EA11-015

SUBJECT: Special Coverage Adjustment - Shift Lever May Not Display Correct Gear

SUBJECT: Special Coverage Adjustment - Shift Lever May Not Display Correct Gear

SUBJECT: Shift Lever Indicator May Not Display Correct Gear

2269484

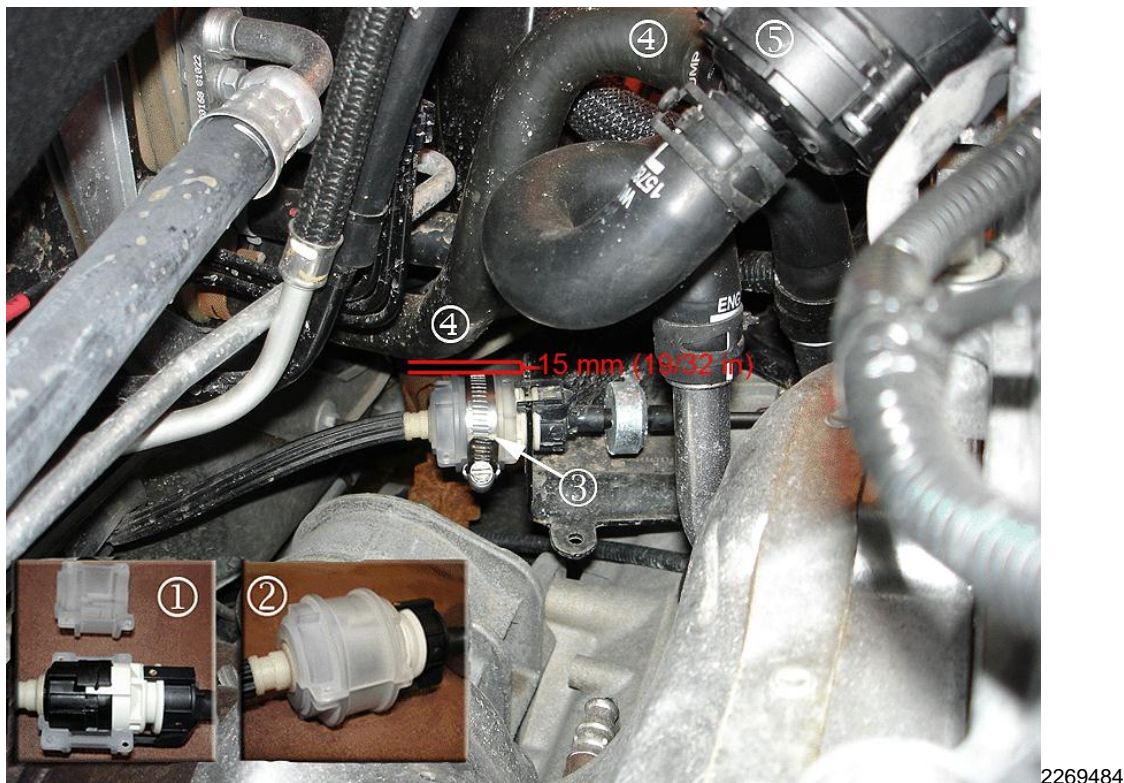
The service procedure in this bulletin has been revised to include the installation of a cable kit (clam shell). Please discard all copies of bulletin 11175.

5. Install the clam shell (1) (2) over the shifter cable locking tabs.
6. Install the service clamp over the clam shell (3). Position the clamp fastener head away from the inlet coolant hose (4). **Tighten the clamp to 4 N·m (35 lb-in).**
7. Ensure that there is 15 mm (19/32 in) of clearance between the inlet coolant hose (4) and the clam shell (3). On hybrid equipped vehicles, it may be necessary to reposition the inlet coolant hose (4) to achieve the required 15 mm (19/32 in) of clearance. **To reposition the inlet coolant hose (4) on hybrid equipped vehicles, locate the heater cooler pump (5) and perform Steps 5.1-5.4.**

Caution: Do not kink or damage the inlet coolant hose (4) when repositioning the hose to obtain the 15 mm (19/32 in) clearance. To avoid damaging the hose clamp, use J-38185 or equivalent hose clamp pliers to loosen the hose clamp.

2269484

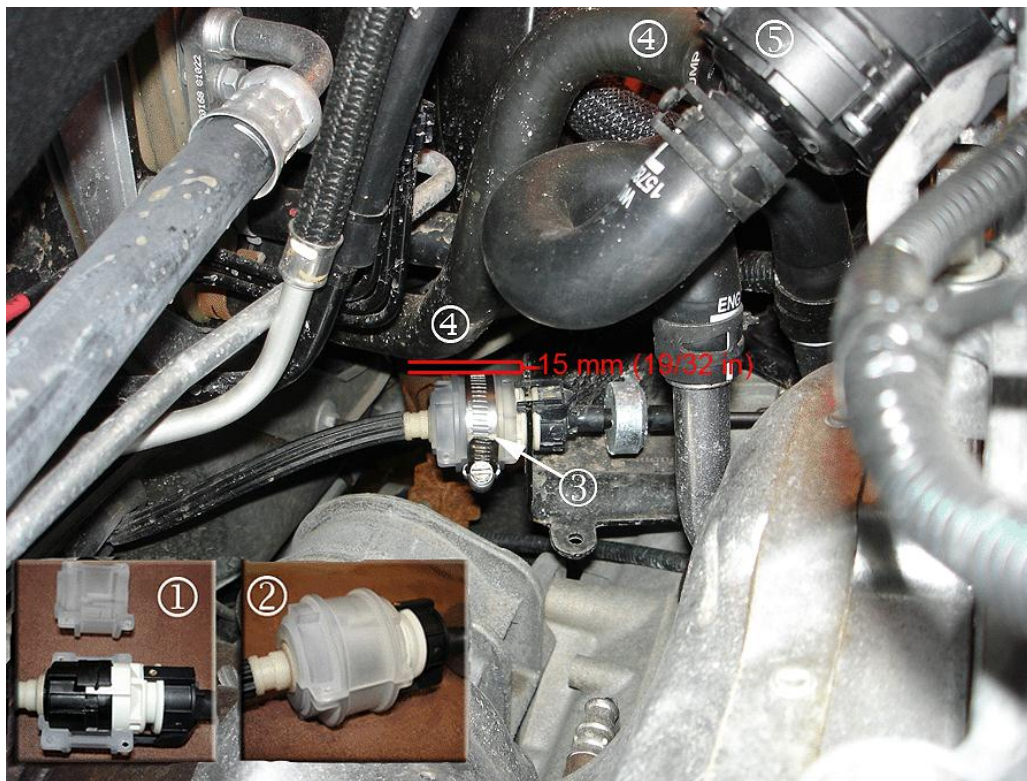
- If the transmission shift cable locking tabs (1) are fractured and separated (A), remove the transmission shift cable and replace it with a new one. Refer to *Floor Shift Control Cable Replacement or Range Selector Lever Cable Replacement* in SI. **Also install a transmission shift cable kit with the new shift cable.**
- If the transmission shift-cable locking tabs (2) are NOT fractured and separated (B), install the transmission shift cable kit. Proceed to Step 3.

3. Install the clam shell (1) (2) over the shifter cable locking tabs.
4. Install the service clamp over the clam shell (3). Position the clamp fastener head away from the inlet coolant hose (4). **Tighten the clamp to 4 N·m (35 lb-in).**
5. Ensure that there is 15 mm (19/32 in) of clearance between the inlet coolant hose (4) and the clam shell (3). On hybrid equipped vehicles, it may be necessary to reposition the inlet coolant hose (4) to achieve the required 15 mm (19/32 in) of clearance. **To reposition the inlet coolant hose (4) on hybrid equipped vehicles, locate the heater cooler pump (5) and perform Steps 5.1-5.4.**

Caution: Do not kink or damage the inlet coolant hose (4) when repositioning the hose to obtain the 15 mm (19/32 in) clearance. To avoid damaging the hose clamp, use J-38185 or equivalent hose clamp pliers to loosen the hose clamp.

2269484

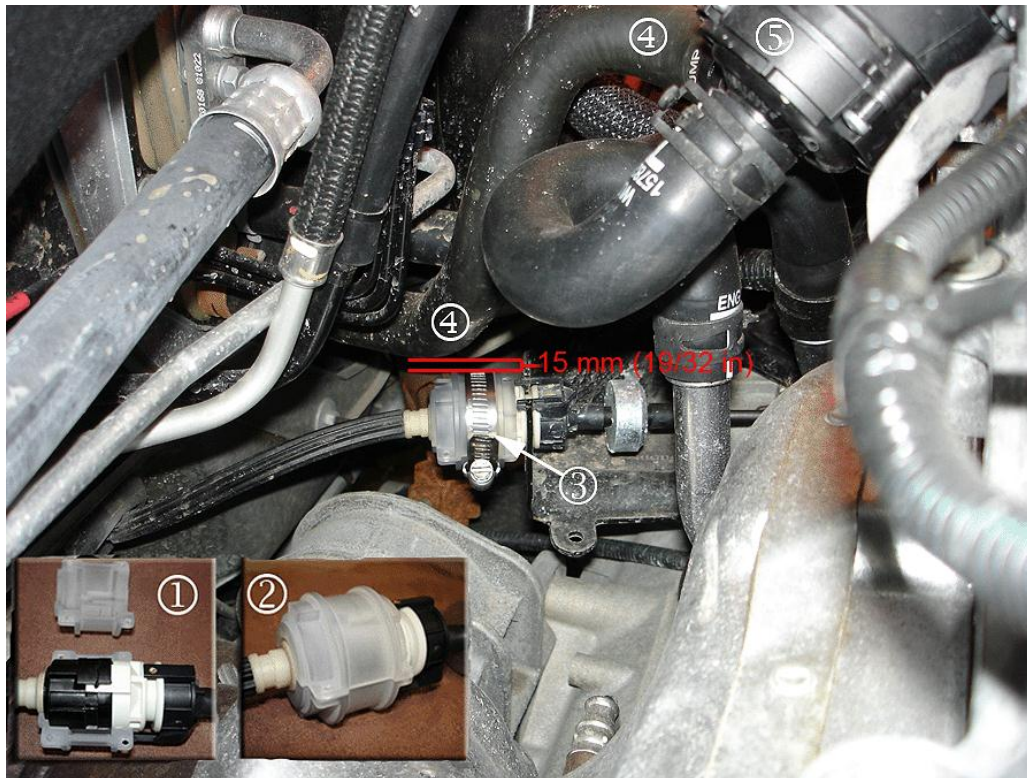
The Service Procedure and Warranty Transaction Information sections in this bulletin have been revised to include an inspection of the transmission shift cables. Please discard all copies of bulletin 12106.

- If the transmission shift cable locking tabs (1) are fractured and separated (A), remove the transmission shift cable and replace it with a new one. Refer to *Floor Shift Control Cable Replacement or Range Selector Lever Cable Replacement* in SI. **Also install a transmission shift cable kit with the new shift cable.**
- If the transmission shift cable locking tabs (2) are NOT fractured and separated (B), install the transmission shift cable kit. Proceed to Step 3.
